# **NORTHWEST ASSOCIATED CONSULTANTS, INC.**

## **MEMORANDUM**

TO: Phil Kern  
FROM: Alan Brixius  
DATE: May 8, 2024  
RE: Delano - Parkview Hills North - 2024 Preliminary Plat / Final  
FILE NO: 432.07 - 24.04

GRADING  
PLAN  
C3-2

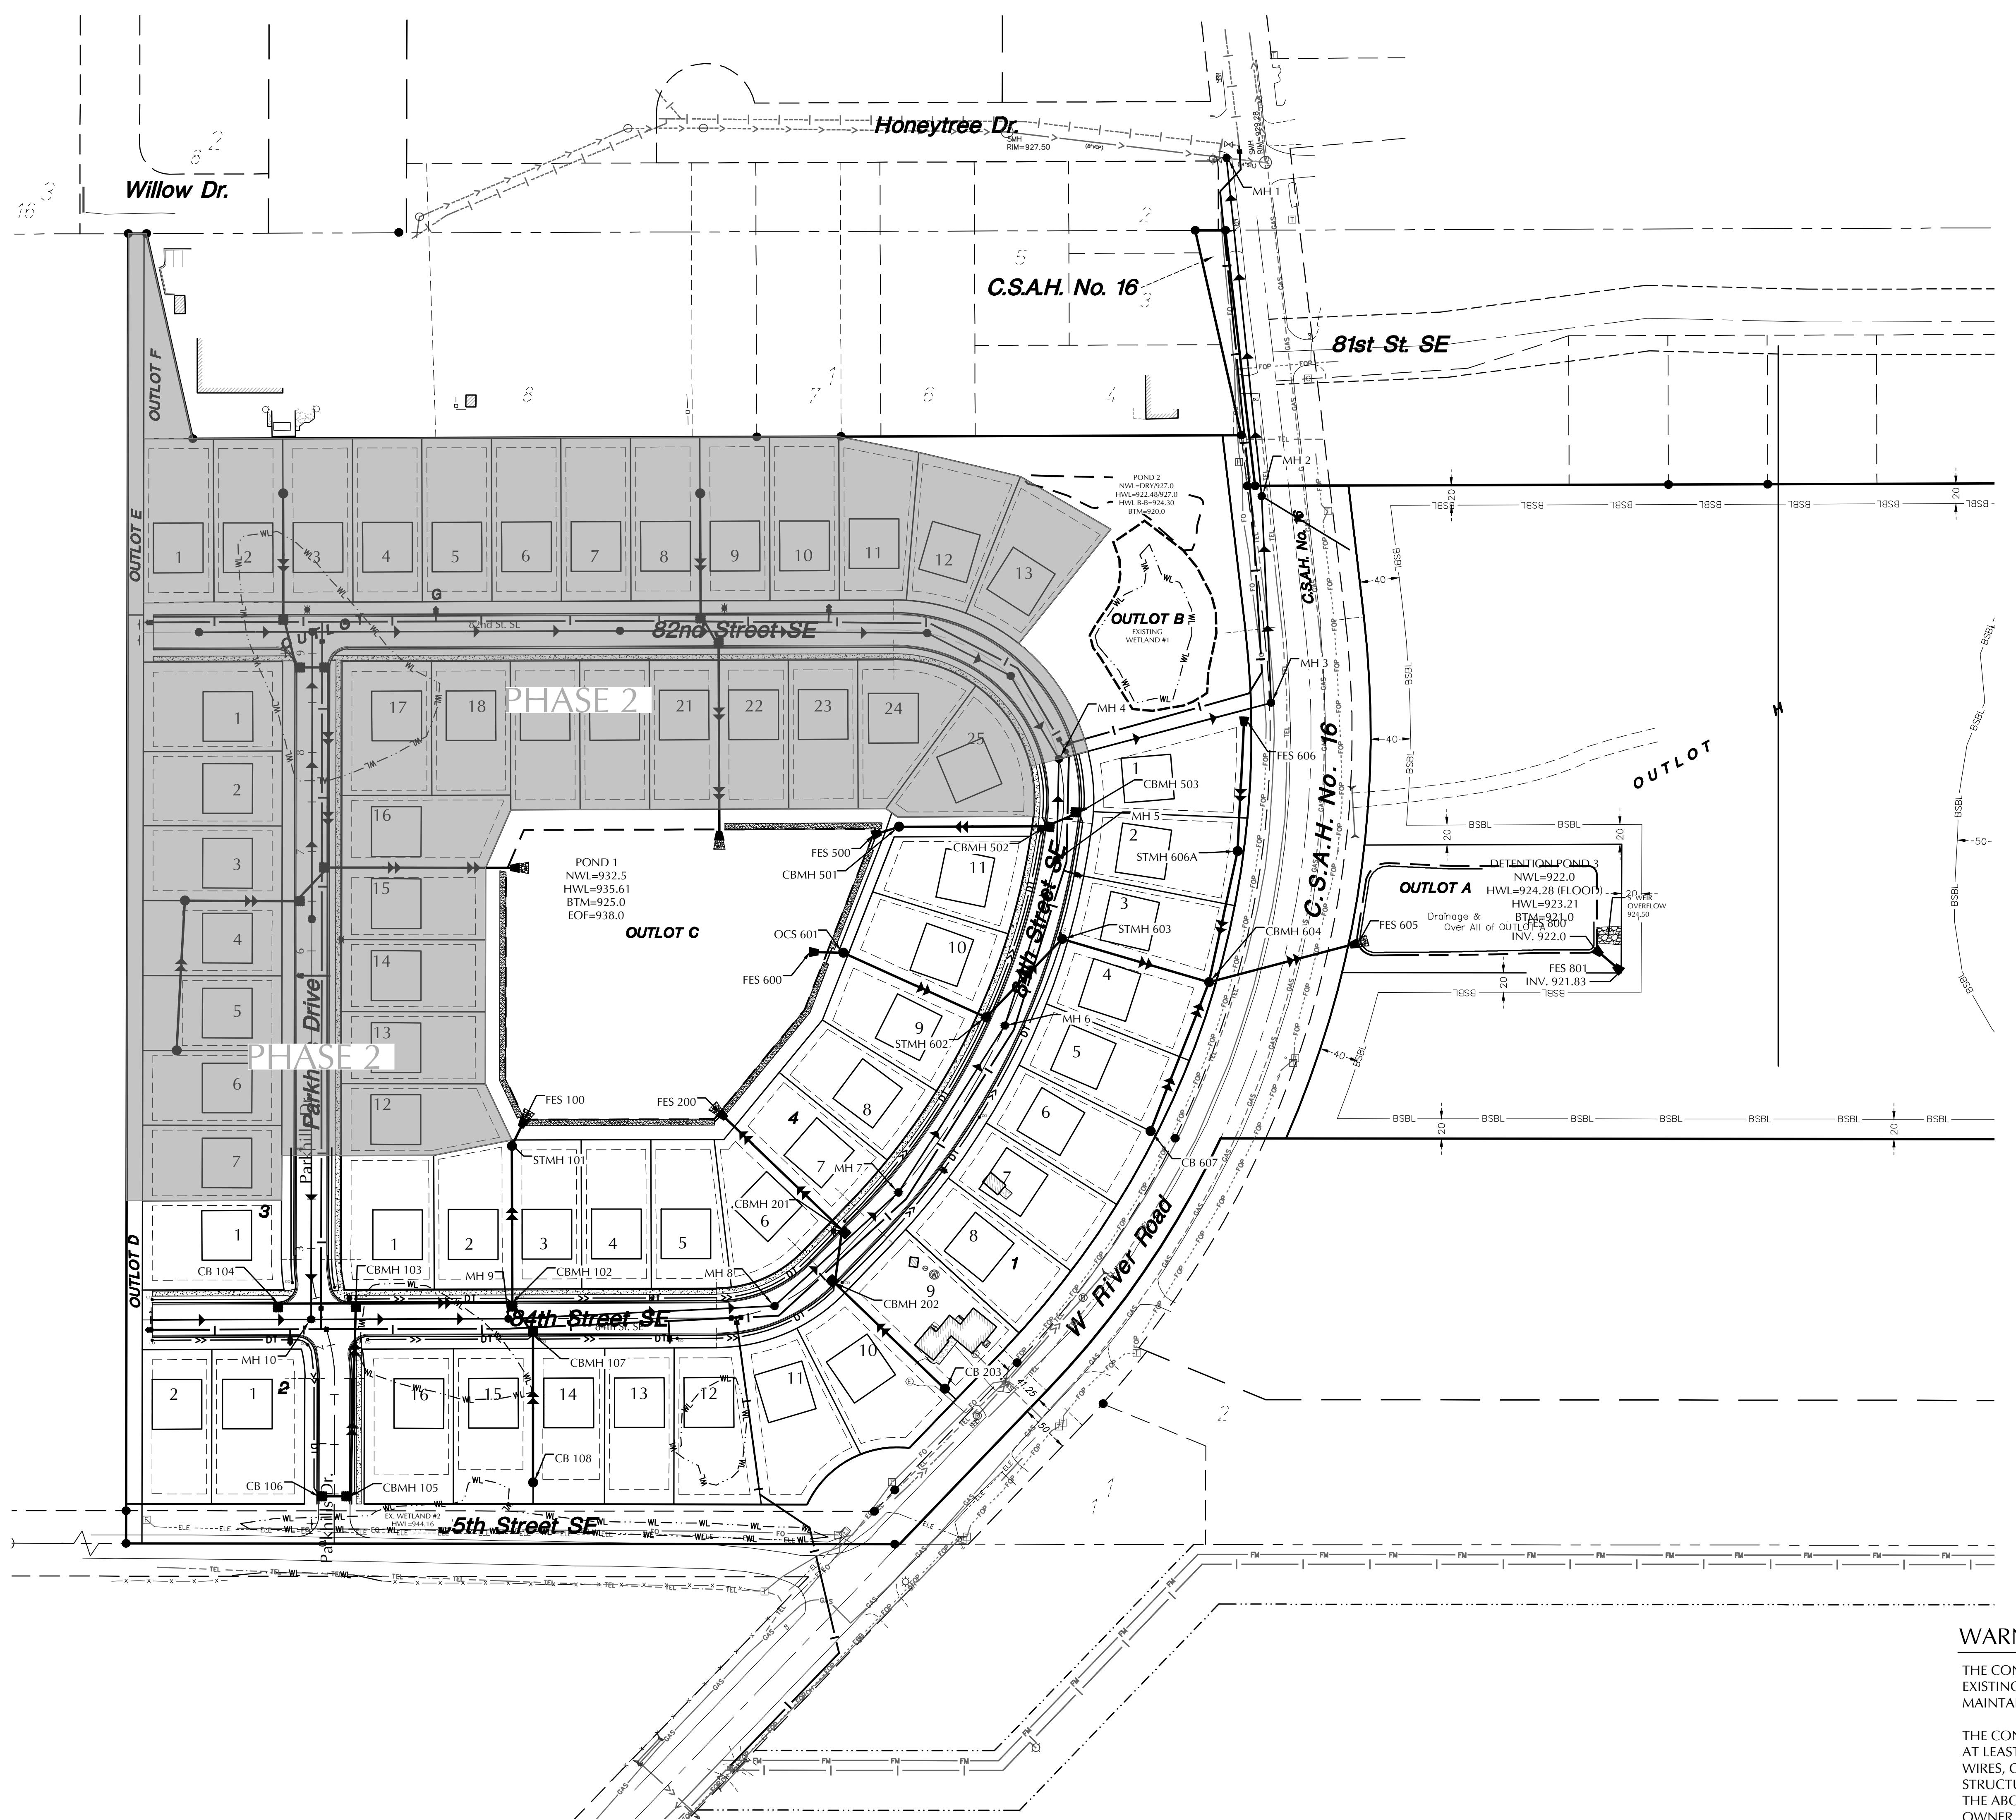
Lots in Block 6 and 7 all exceed the lot size standards. These lots have additional lot depth in an effort to preserve trees along the west and north plat boundaries. The Grading plan (Exhibit E) shows drainage swales across rear lots to catch basins. The location of these swales runs through the rear yards of these lots between the building pads and the tree preservation area. These swales must be located within a drainage and utility easement to prevent alterations that may impede the approved drainage patterns. The swale and easement will limit the ability to use the rear yard. No sheds, decks, fences, or filling may be allowed within the easement that may obstruct the approved drainage patterns in Block 6 and 7. The plat must be revised to establish the needed drainage and utility easement over the drainage swale. As a condition of plat approval easement restrictions shall be included as deed covenants and in the sales materials for these impacted lots.

1. The grading plan shows a storm sewer along the rear lot lines of lot 1 – 5. This will not allow buffer yard plantings within the lots.
2. The Landscape plan shows the buffer yard planting within County Road 16 right-of-way. This is not acceptable in that the landscaping is outside the plat.
3. The house pad will be 2 to 4 feet higher than the rear lot line elevation. This will reduce the effectiveness of the 6-foot-tall coniferous trees as screen.

In review of the grading plan, we recommend expanded easements must be placed over drainage swales located within the rear yards of Blocks 6 and 7 to preserve the proposed rear yard drainage patterns of the lots within these Blocks. Individual lot improvements cannot interrupt the rear yard drainage patterns to the detriment of the adjoining properties.

1. The grading, drainage, stormwater management, and erosion control plans shall be subject to the review of the City Engineer.
2. The grading plan indicates that house elevations are a minimum of 18 inches above the street curb. Homes must be located two feet above pond elevations, high water elevations, and one-foot above emergency overflows for low openings.
3. The submitted landscape plan must specify the following stormwater-related items:
  - Outlot, wetland, pond easement demarcation posts at the periphery of these outlots and easements to prevent trespass, mowing or buildings encroaching into these Outlots, stormwater drainage ways or ponds.
  - Tree preservation fencing shall be installed prior to the start of grading. The type, location and installation of the tree preservation fencing shall be approved by the City Engineer prior to initiating grading.

1. The Storm sewer shall be shifted to the rear lot lines of Block 1.
2. All buffer yard landscaping shall be located within the rear yards of the lots. Maintenance of the landscaped buffer yards shall be the responsibility of the future lot owners.
3. Landscaping shall be coordinated with the grading plan to maximize the screen effectiveness.
4. Drainage and utility easements shall cover the rear yard drainage swales.

13. The submitted preliminary and final plats shall be revised to illustrate all easements. Easements shall be placed over rear yard drainage swales. All easements shall be subject to review and approval of the City Engineer. No construction of sheds, fences, patios or filling may occur with the drainage and utility easements.
